## Agenda for Eagleville Planning Commission

**b. Preliminary Plat – Review and Approval of a Request by Salem Creek Partnership for a 204 Lot Subdivision to be Located at 742 West Webb Road – Zoning R-2/ PRD**

Review and Approval of Preliminary Plat

RE: Preliminary Plat and Responses to the City of Eagleville Planning and Engineering Comments relating to the "Stephenson Farms" Planned Residential Development located within Rutherford County Tax Map 141, Parcel 1 (187.51 acres).

REFERENCE SHEET C0.2 OF THE STEPHENSON FARMS SUBDIVISION  
PRELIMINARY PLAT S.E.C. PROJECT#21072 AS REVISED 6/26/2024  
AND SUBMITTED TO THE CITY OF EAGLEVILLE, TENNESSEE.

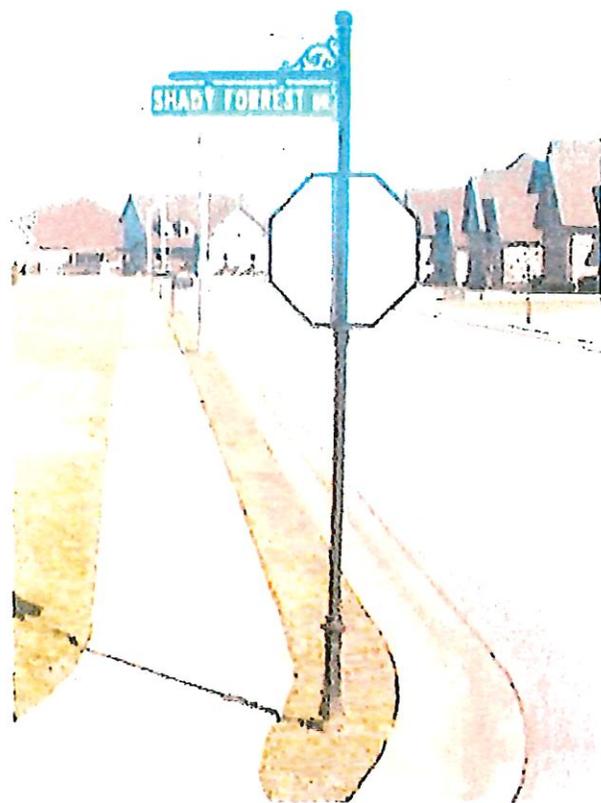
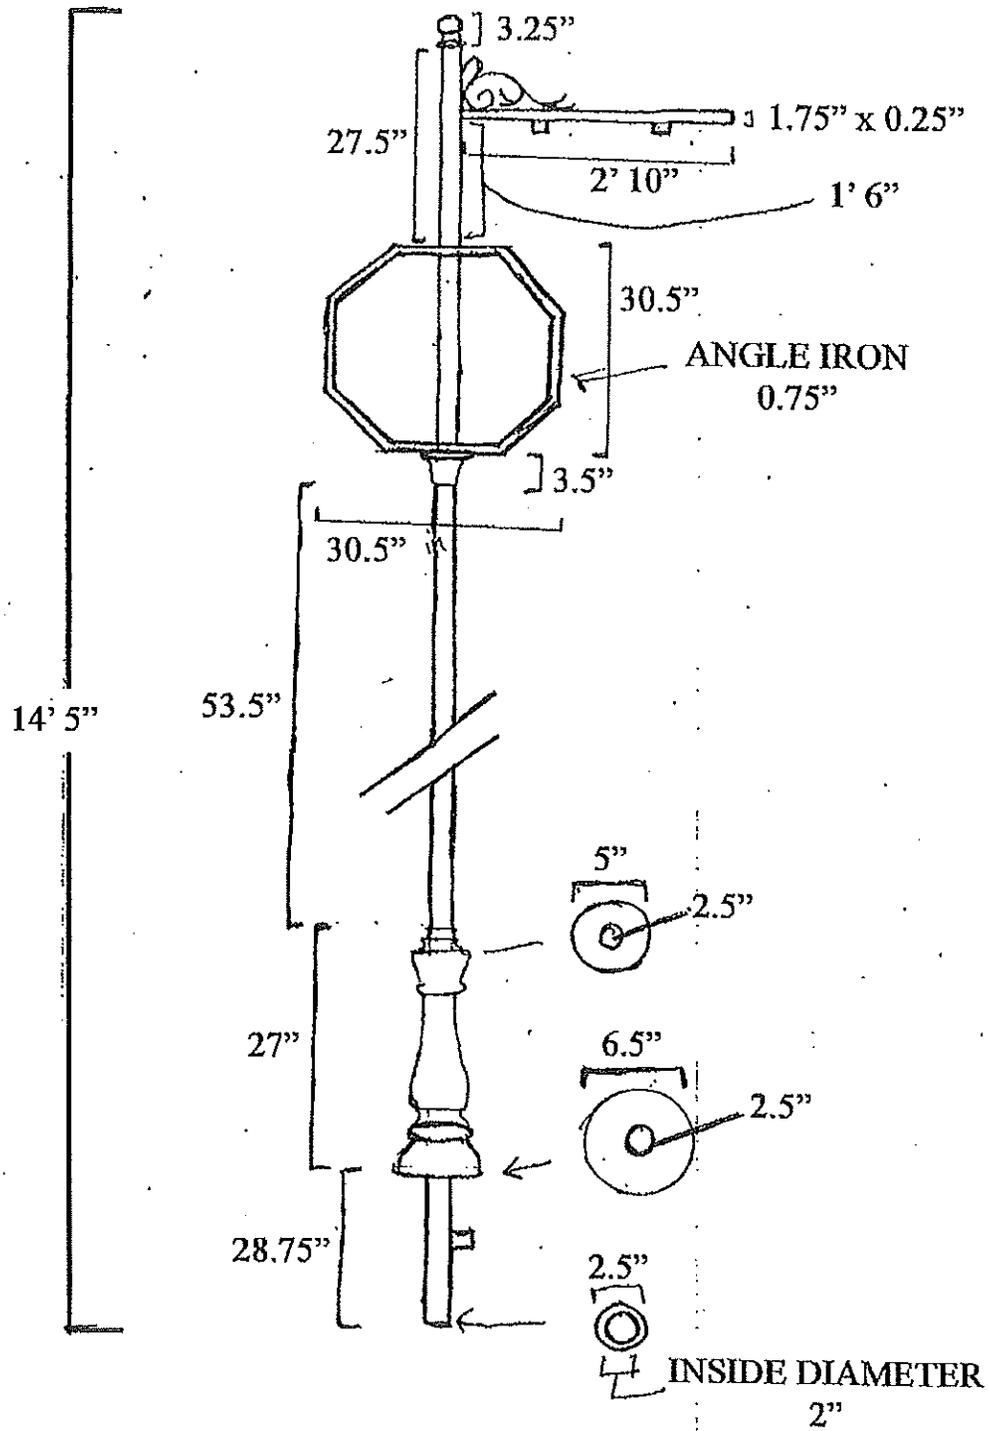
- 5) Added labels for the 14-ft wide compacted gravel access drive from College Grove Road back to the STEP system. Along with a note on timing of the gravel access drive transitioning from gravel to city ROW standards along Spotted Owl Drive in Phase 6 and paved ROW connection from Winterbrooke.

Sheet C0.0 Farms Subdivision  
 Preliminary Plat  
 S.E.C. Project #21072  
 Date: 4-16-2004  
 Revised: 5-26-2004 Comments  
 Revised: 7-31-2004 No Comments

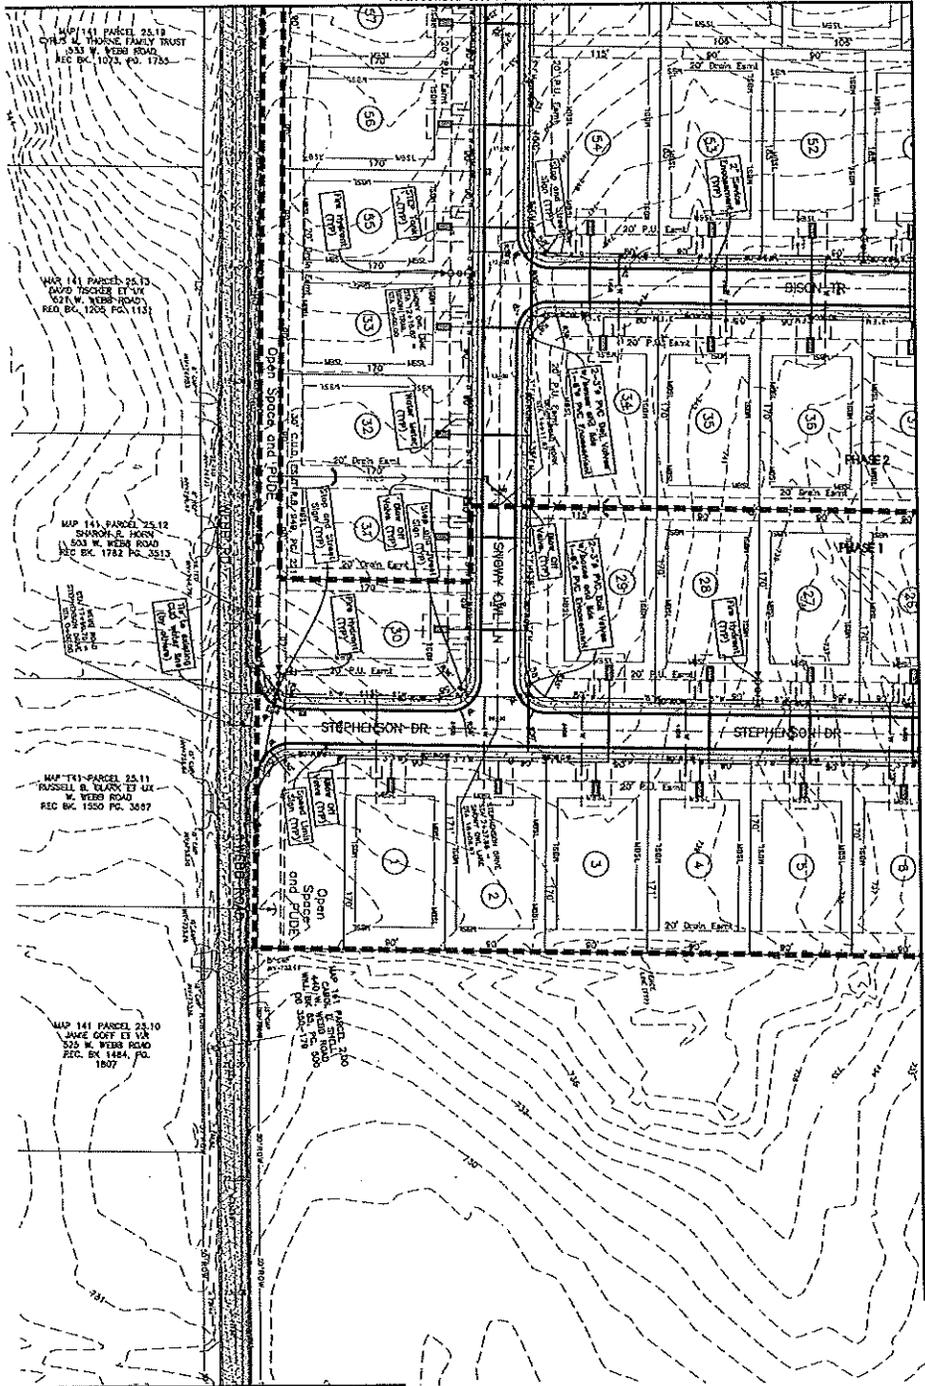
1. Cover Sheet: Retitle Master Plan to be Overall Plan. Retitle Preliminary Plan to be Preliminary Plat. Retitle Offsite Road Improvements Master to be Offsite Road Improvements Overall. **Updated.**

2. Correct Zoning to be R-2 PRD. Note approval date of Zoning. **Updated**
3. Under Total Site Data, If this preliminary plat submittal is for condidation of all phases, include all phases in this list. If only for Phase 1, revise titles and heading to state Phase One only. **All phases are shown.**

4. Darken phase lines for clarity. **Done**
5. Include trail layout n the overall sheet. Additional access points may be necessary. **Done and understood.**
